Access Compliance Report

Public Rights-of-Way

(Curb Ramps)

Intersection ID: 10033070	Main Street: NORTH_COMMUNITY_HOUSE_RD	Cross Street: N/A	Location: NE
ADA ID: F72BEA42F86A	Ramp Type: Perp	Initial Pass/Fail: Fail	Overall Compliance: No
		Severity Score: 12.5	
Codes/Mitigation Info/Possible Solution		Field Measurements/Component Compliance

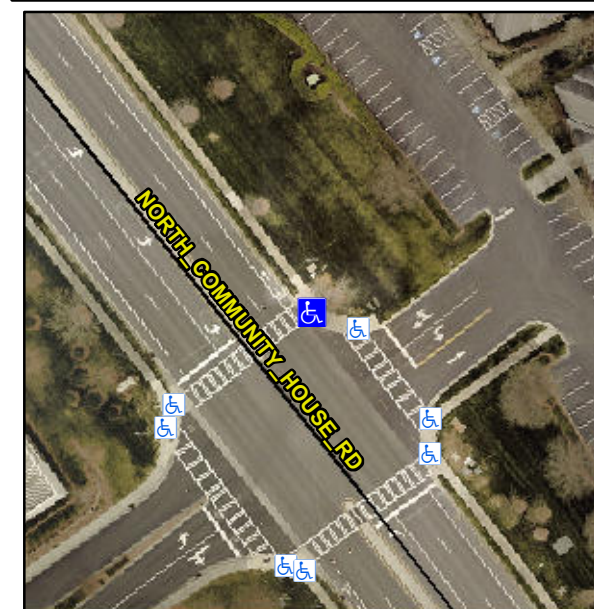
R304.2.2

Compliance	Description	Data	Compliance	Description	Data
N/A	Ramp Length (in)	24.0	No	Ramp Slope (%)	8.5
Yes	Ramp Width (in)	48.0	Yes	Ramp XSlope (%)	1.8
N/A	Flare Type LT	N/A	N/A	Flare Type RT	N/A
N/A	Flare Slope LT (%)	N/A	N/A	Flare Slope RT (%)	N/A
N/A	Flare Traversable LT?	N/A	N/A	Flare Traversable RT?	N/A
N/A	Landing Length (in)	N/A	N/A	DWS Provided?	N/A
N/A	Landing Width (in)	N/A	N/A	DWS Contrast?	N/A
N/A	Landing Slope (%)	N/A	N/A	DWS Length (in)	N/A
N/A	Landing X Slope (%)	N/A	N/A	DWS Full Width?	N/A
N/A	Landing Curb? (Y/N)	N/A	N/A	DWS Offset (in)	N/A
N/A	Shared Landing?	N/A			
N/A	Gutter Ponding?	N/A	N/A	Gutter Slope (%)	N/A
N/A	Gutter Lip Ht (in)	N/A	N/A	Gutter X Slope (%)	N/A
N/A	Painted X Walk1?	Yes	N/A	Painted X Walk2?	N/A
	X Walk 1 Direction	To SW		X Walk 2 Direction	N/A
N/A	X Walk 1 Width (in)	111.0	N/A	X Walk 2 Width (in)	N/A
	X Walk 1 Slope (%)	0.3		X Walk 2 Slope (%)	N/A
	X Walk 1 X Slope (%)	1.7		X Walk 2 X Slope (%)	N/A

Remove & Replace Entire Ramp.
